MFN 10-051 Revision 1  
March 8, 2011

**Subject:** Revision to Administrative Amendment 34 to GESTAR II to Implement the Referencing of NEDC-33006P, Maximum Extended Load Line Limit Analysis Plus and NEDE-32906P, Supplement 3-A, Migration to TRACG04 / PANAC11 from TRACG02/PANAC10 for TRACG AOO and ATWS Overpressure Transients

Markup of Section 4 References of GESTAR II Main  
and Sections 1-6 of GESTAR II US Supplement

Figure S-3-6. Scenario 2 Krypton Whole Body Dose with Respect to Charcoal Hold Up

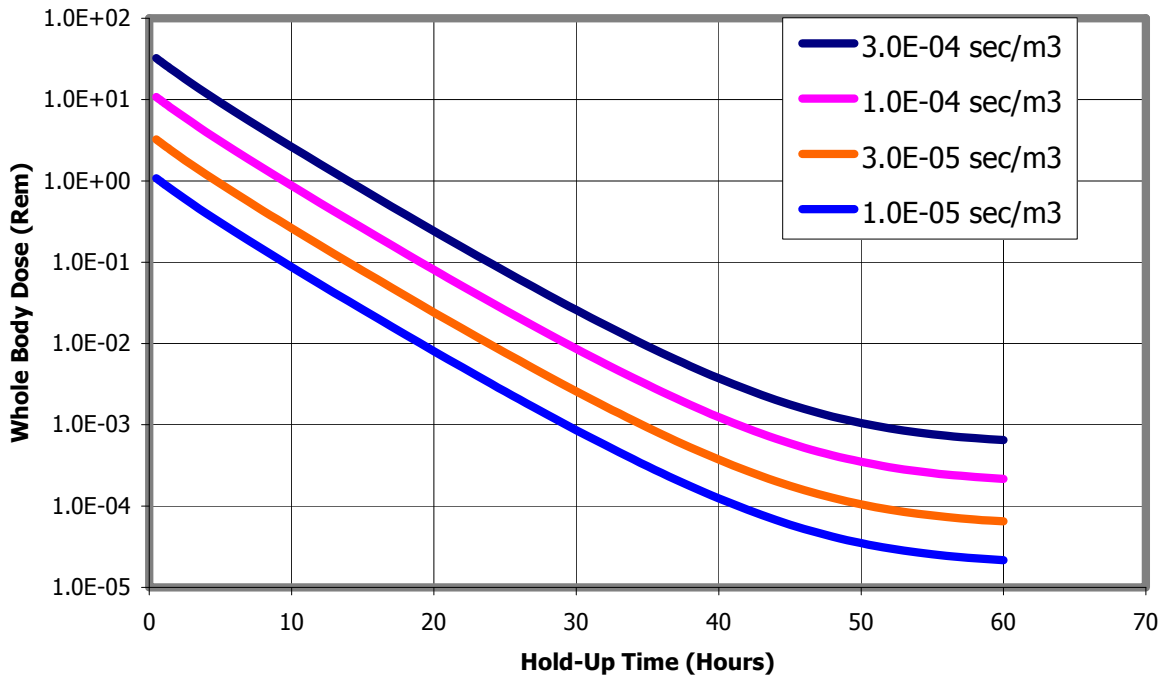
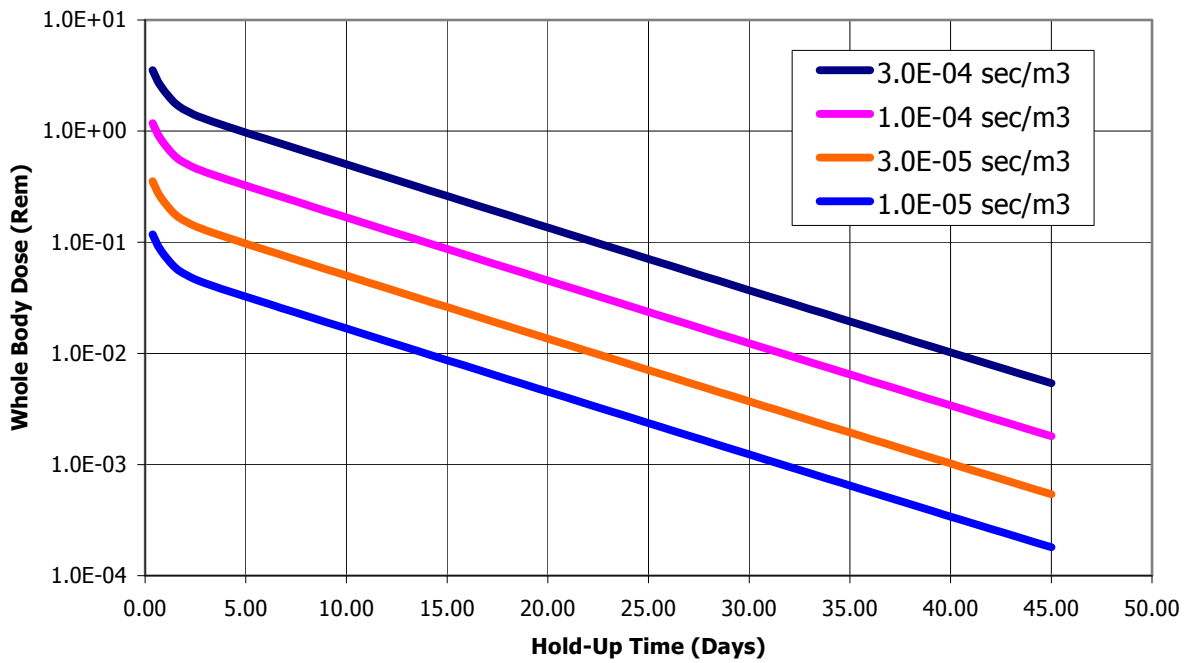
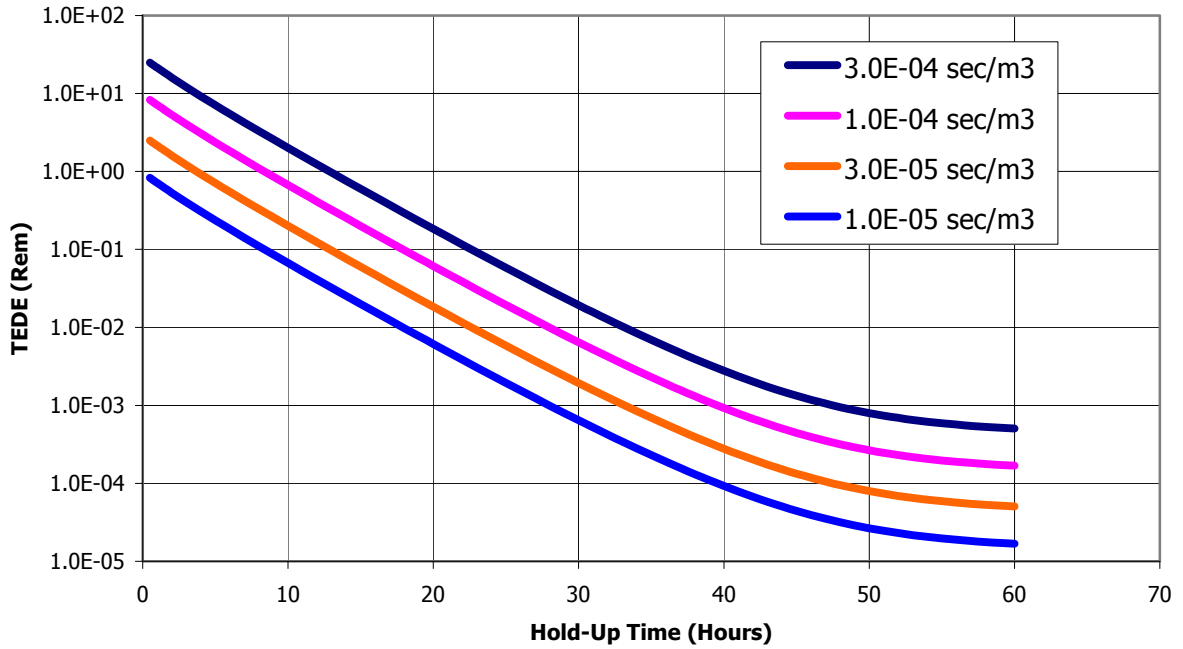
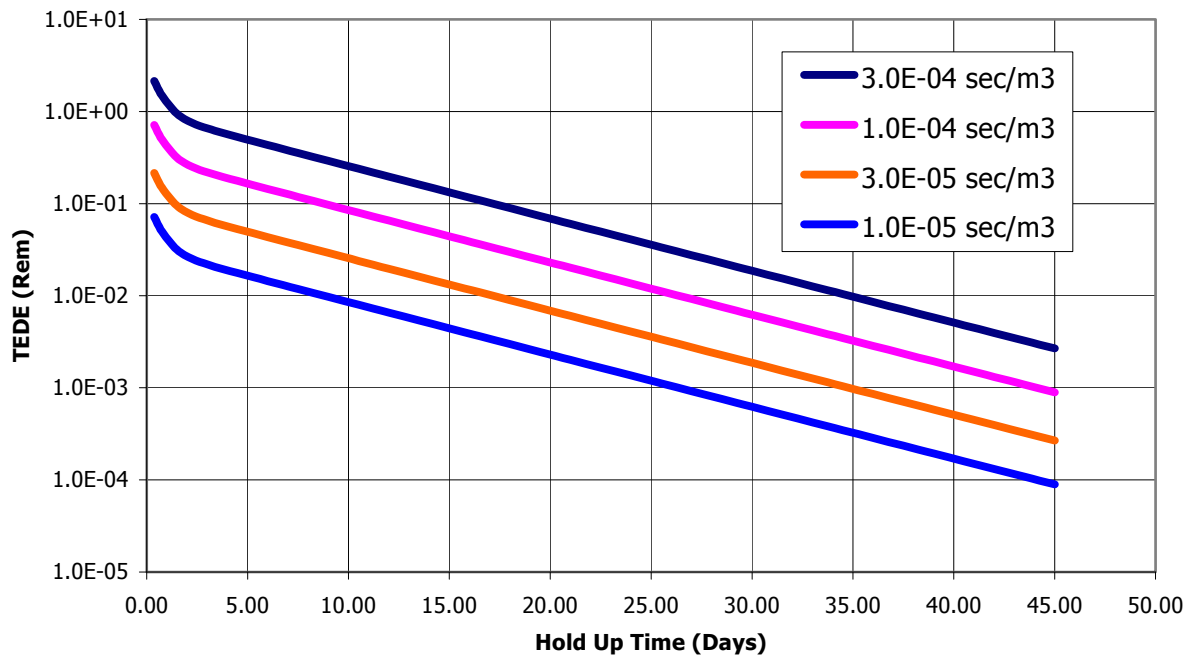
For plants with a 10CFR100 radiological basis, Figures S-3-6 and S-4-7 will be used to confirm the applicability of the generic analysis. Three parameters are needed to use these figures: the 2-hour Chi/Q value at the EAB and the hold-up time for krypton and xenon.

In a similar fashion, plants with a 10CFR50.67 radiological basis will use Figures S-5-8 and S-6-9 to confirm the applicability of the generic analysis. Using the plant specific parameters, the plant must confirm that the plant specific result is less than the 2.5 Rem TEDE dose limit.

Figure S-7 Illustration of Scram and Controlled Entry Region Boundaries for BSP for Option III

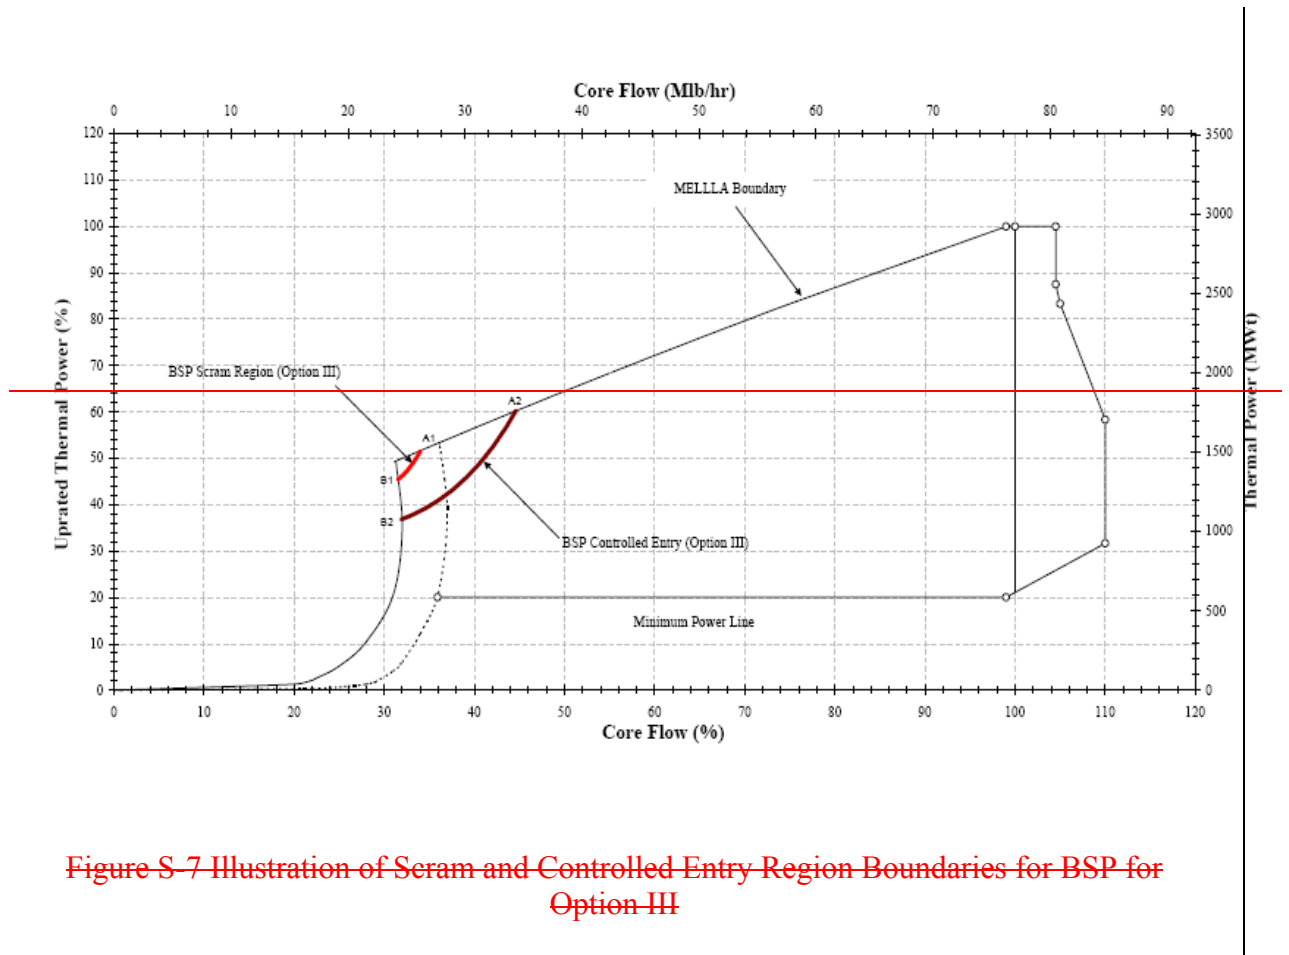
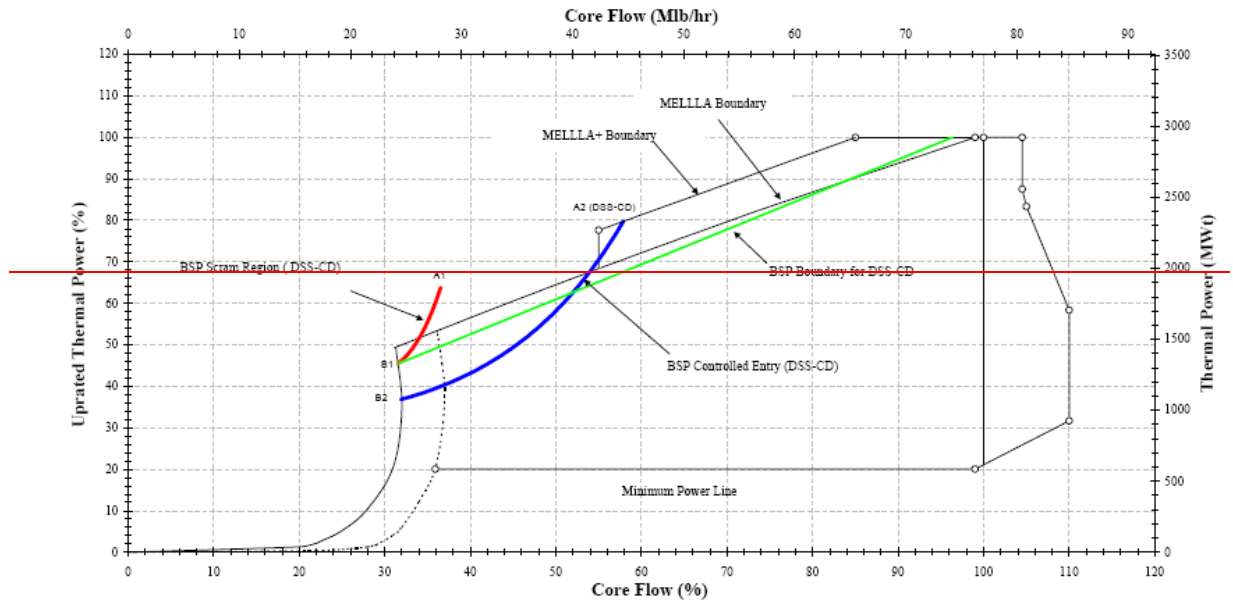
The typical calculated stability region boundaries are illustrated in Figure S-73 where the four calculated endpoints A1, A2, B1, B2 are based on a core decay ratio criterion of 0.80.

The typical calculated stability region boundaries and the BSP Boundary are illustrated in Figure S-84; the three endpoints A1, B1 and B2 are calculated based on a core DR criterion of 0.80 while the A2 endpoint is calculated based on a core DR criterion of 0.60. The 0.60 criterion for the A2 endpoint (as illustrated in Figure S-84) provides additional stability margins for operation at off-rated conditions and for a two-pump trip to natural circulation flow.
